Order by the Building Authority under section 24(1)

Order No :	C/TE/000509/16/K	Office of the Building Authority
BD Ref. :	EB/4006/95/T04S	12/F - 18/F., Pioneer Centre, 750 Nathan Road, Mongkok, Kowloon.
To :	The Owner of 17TH FLOOR OF 38 PLAZA NO.38 SHANTUNG STREET KOWLOON	Date: 18 March 2016

Owner(s) of the premises at 17TH FLOOR OF 38 PLAZA NO.38 SHANTUNG STREET KOWLOON
on (Lot Number) K.L.L.10514 R.P.

17TH FLOOR PLAN

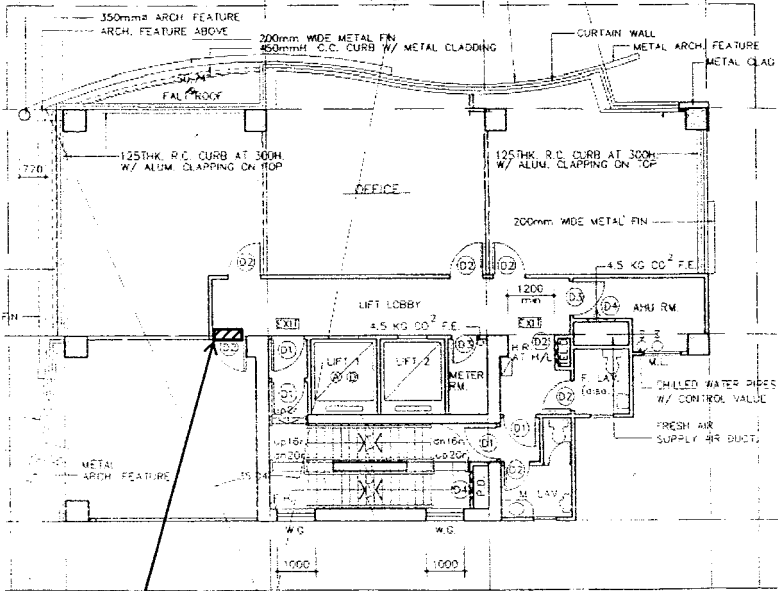
- (i) **A fire-resisting door at the entrance of the premises removed and replaced by a door of inadequate fire rating.**
(The location of the building works described above is shown hatched-black on the plan annexed hereto, for the purpose of identification only)

- (a) As a result of the building works at items (i) above, Regulation 90 of the Building (Construction) Regulations, which requires the building to be designed and constructed so as to inhibit or provide adequate resistance to the spread of fire and smoke; and to maintain stability of the building in case of fire, has been contravened.

- (a) reinstate the parts of the building so affected by the building works under item (i) above in accordance with the *plans approved by the Building Authority / ~~minor works completion record submitted to the Building Authority.~~
